## QW-162 GUIDED-BEND TEST PROCEDURE

## (17) QW-170 TOUGHNESS TESTS

**Figure QW-462.1(a)**  
**Tension — Reduced Section — Plate**

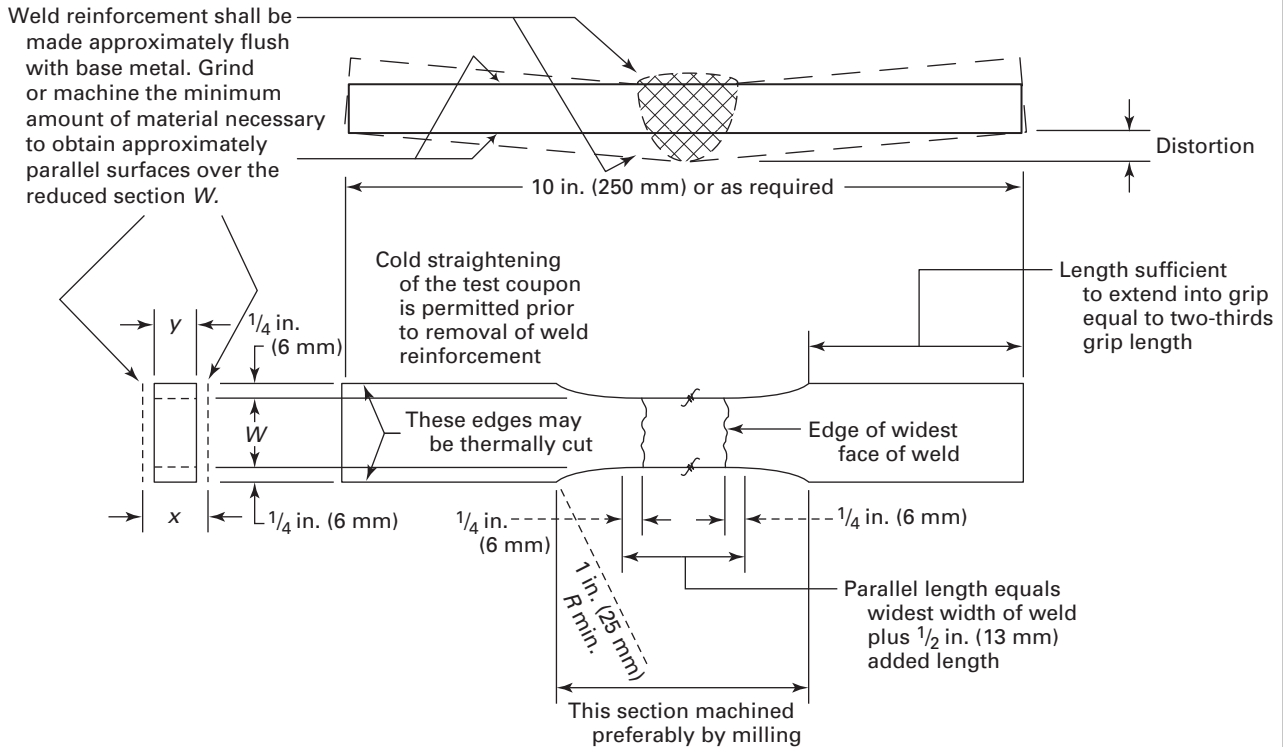
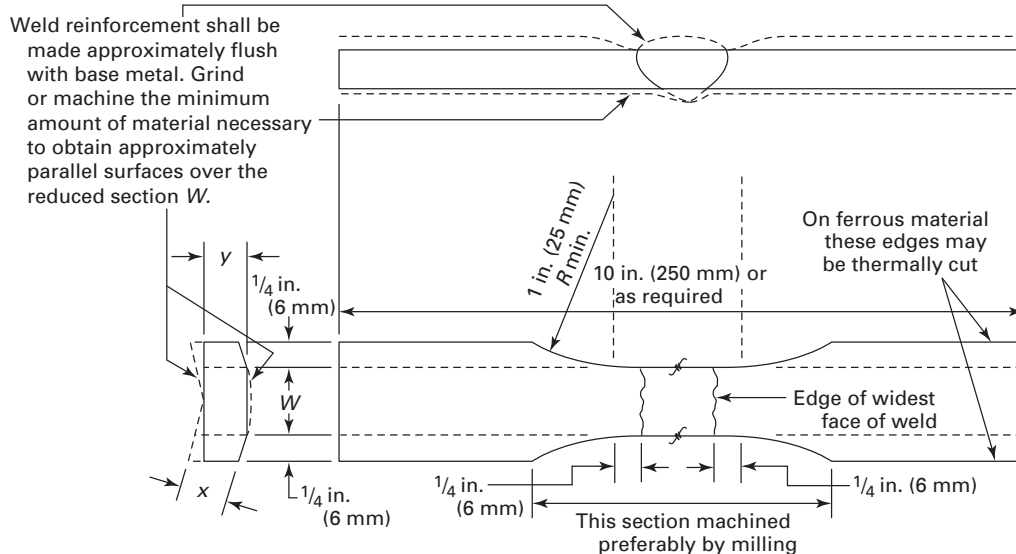
Note to Editor: move General Note out of box, as it applies to both figures on this page, see record# 14-2165.
